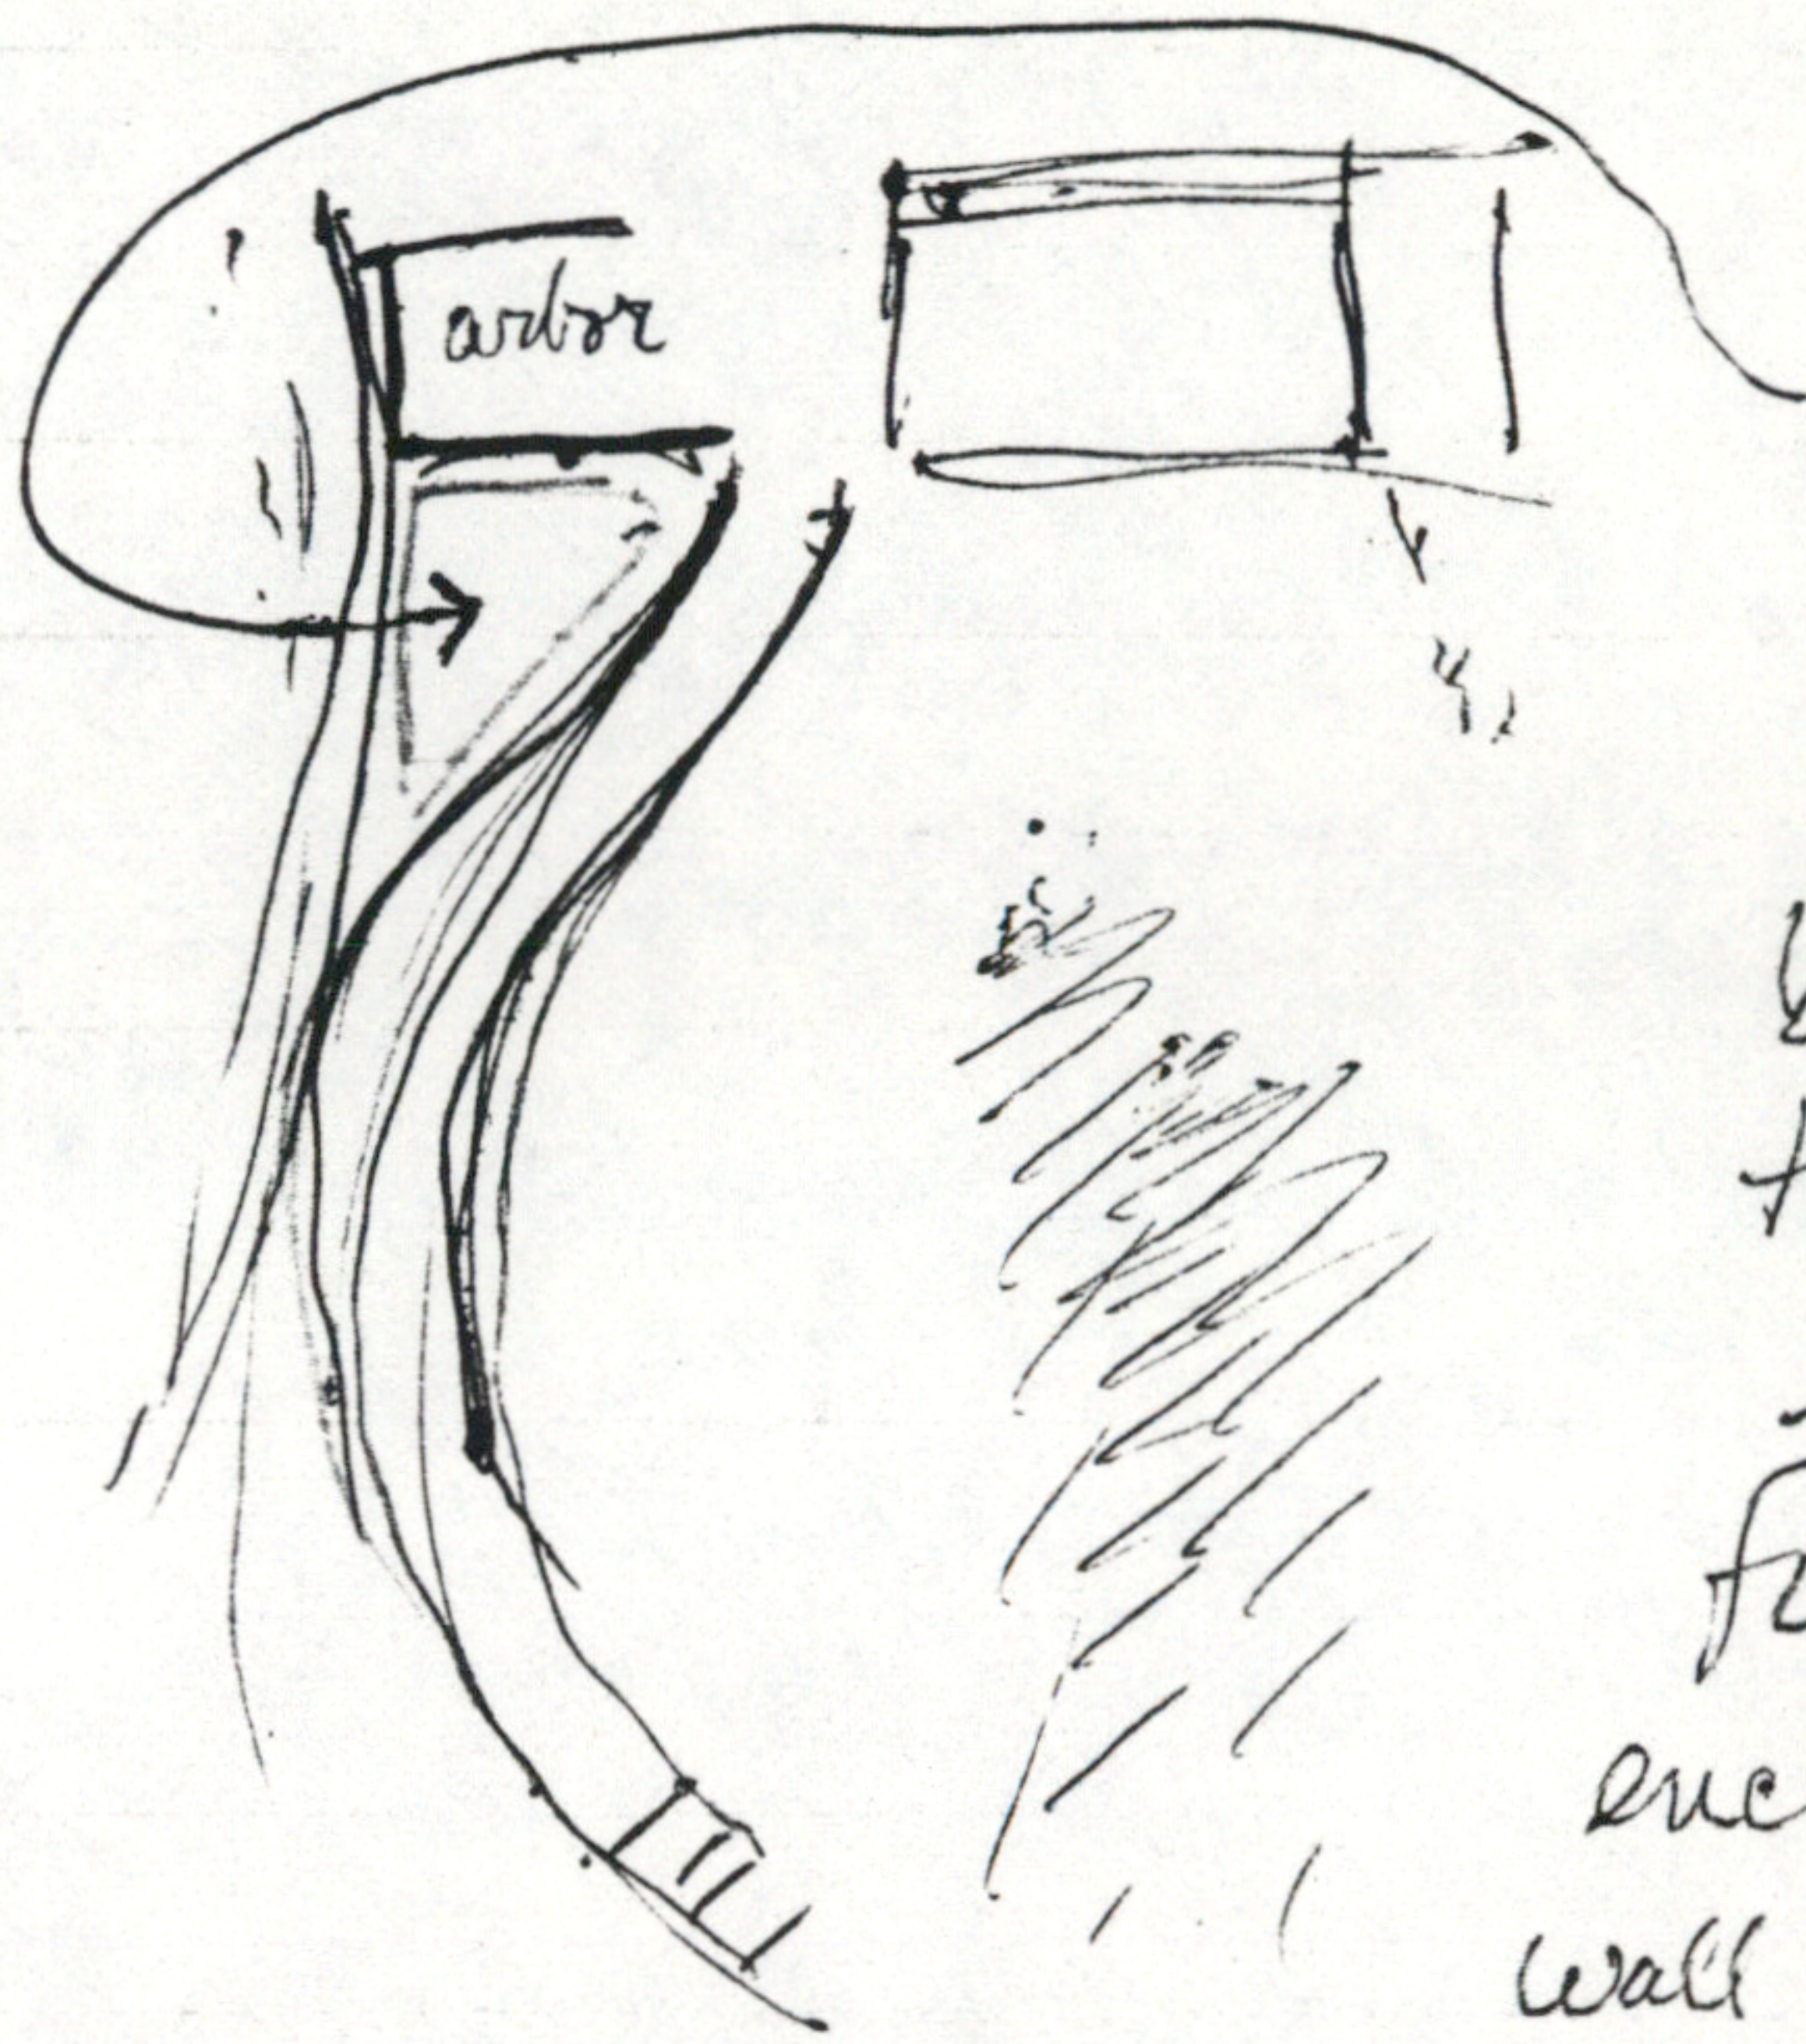
6. ~~The~~ The grape arbor idea at the last gateway has a few problems — or so it seemed at the site. 1<sup>st</sup> if it is an open arbor, a person approaching would ~~go~~ cut straight through it rather than follow the path. So, it has to be walled. If it is walled on both long sides, as it looks to be drawn on the map, with its open side opposite the north wall of our house, it will be a very intimate space, but it doesn't seem like it would be used by the whole cluster — it is too much an extension of the first house in feeling. — Maybe this could turn into a tool + bike shed for the cluster — or screened off laundry area, which would push the arbor into the common area more, and move the entrance to it into the common land. This assumes keeping the arbor section over the gateway itself.

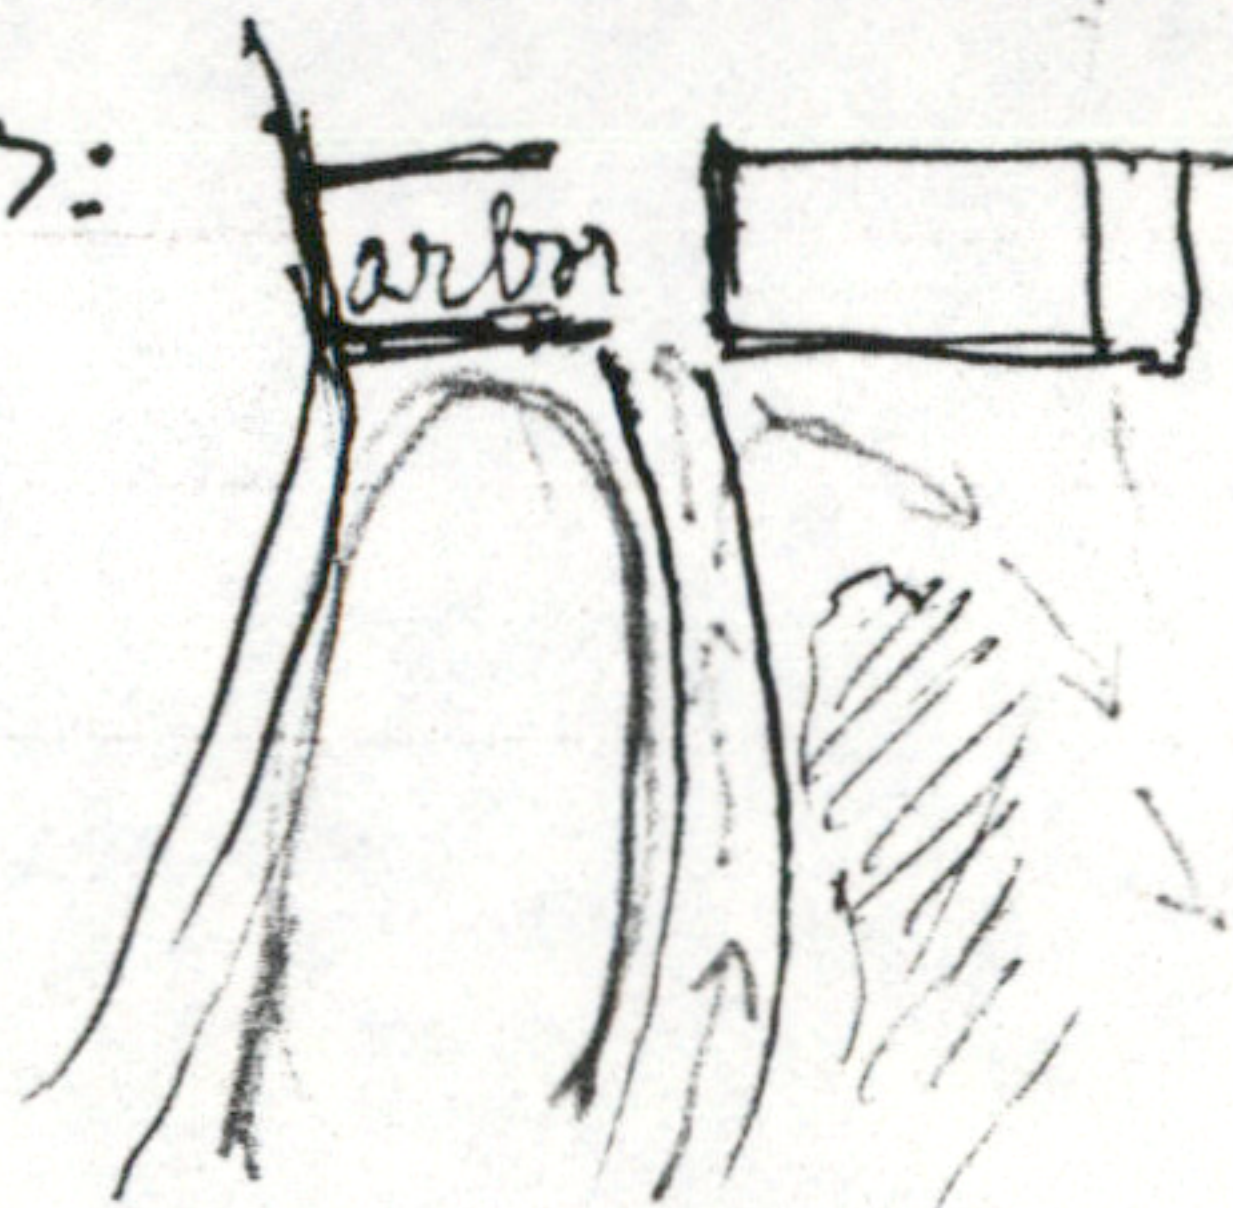
I also wonder about the path approach from the first cluster to our gateway,

because of the dead corner formed outside.

If the path comes straight, or bows to the right, from the last cluster, it will form a field (playing field?), enclosed by the natural wall on one side, + the

path on the other, making a ~~more~~ <sup>better</sup> reason to approach the ~~gate~~ cluster at the <sup>Point</sup> of the gateway and will also include, + use, that dead corner:
